1.2 General Plant Description

The information in this section of the reference ABWR DCD, including all subsections, tables, and figures, is incorporated by reference with the following departures and supplements.

Figure 1.2-1 Site Plan

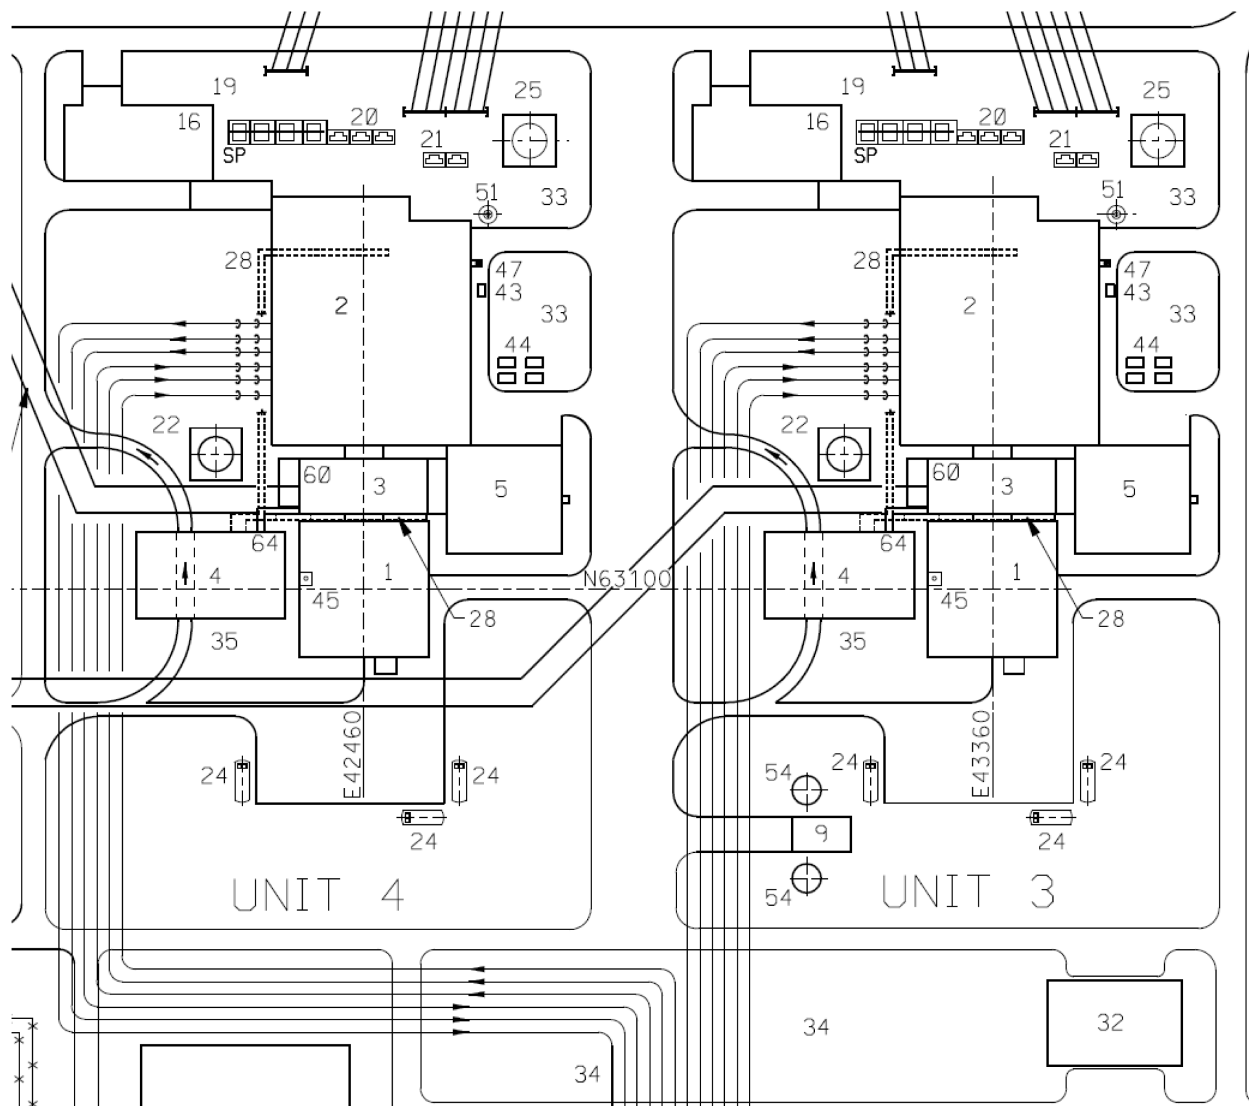
STP DEP 1.1-2 (Figure 1.2-1)
